6.2 272-280 NORMANBY ROAD, SOUTH MELBOURNE
LOCATION/ADDRESS: 272-280 NORMANBY ROAD, SOUTH MELBOURNE
EXECUTIVE MEMBER: KYLIE BENNETTS, GENERAL MANAGER, CITY GROWTH AND DEVELOPMENT
PREPARED BY: SIMON GUTTERIDGE, PLANNING TEAM LEADER FISHERMANS BEND

- 1.1 To provide a Council position for a request to the Minister for Planning to prepare, adopt and approve Amendment **C207port** to the Planning Scheme for 272-280 Normanby Road, South Melbourne, including for the Fishermans Bend Standing Advisory Committee.

Figure 11.3.7-1 Draft Park Design (Source: Oculus and Tract)

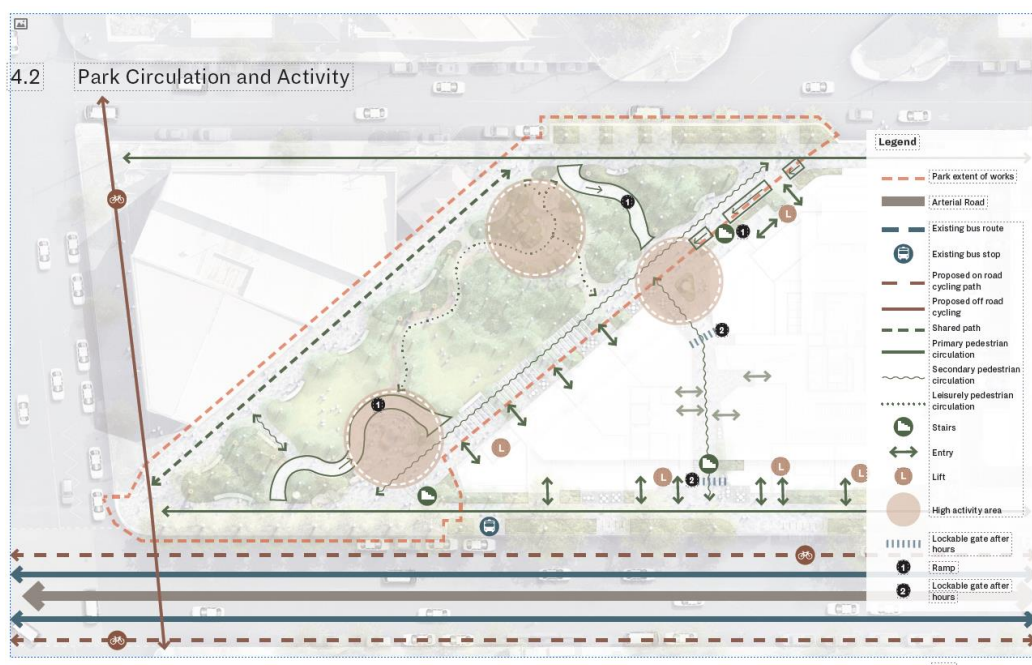
Officers acknowledge the draft park design for Johnson Street includes wild spaces and pedestrian and cycling through-paths, but also recognises it proposes lawn, seating and play areas (Refer plans below).

Noting this mix of passive and active use of the park space, a variation to Clause 4.46 to achieve the walking comfort level at the Johnson Street Park is not supported.

It is considered the proposal should not make the wind conditions on Johnson Street worse than they are at present and a variation for the park to achieve the standing comfort criteria by incorporating wind amelioration plantings as per the applicants new wind report could be supported.

Swept path analysis:

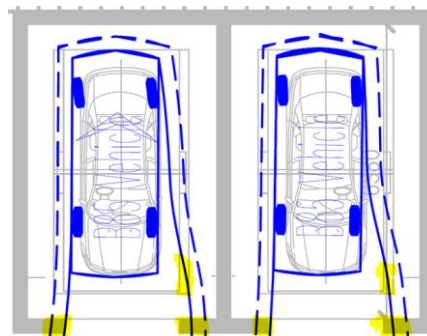
- The usable area of the car lift is unclear. The car lift must adequately cater for a B99 vehicle.
- As part of the queuing assessment, a 10 second vehicle entry and departure has been assumed. To improve safety and ensure timely ingress/egress from the lift, the lift is to be fitted with sensors / digital displays to guide motorists as available by the manufacturer.
- Car lift access concerns in Swept Path Analysis below is to be addressed.

- Swept paths show a B85 vehicle entering and exiting the car lift. The lift access points need to be adequately widened to not encroach into the 300mm clearance area. As currently proposed, the vehicle will hit the lift entry point. Further, the applicant is to confirm the suitability of the vehicle envelope when driving on the lift platform. An easy to access lift is important based on the assumption of a 10 second entry and exit time.

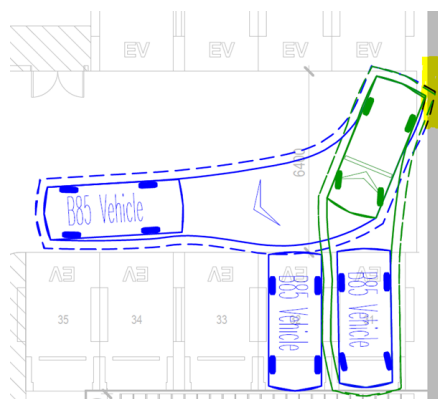
Parking aisle walls at dead-end spaces have not been adequately designed. See below.
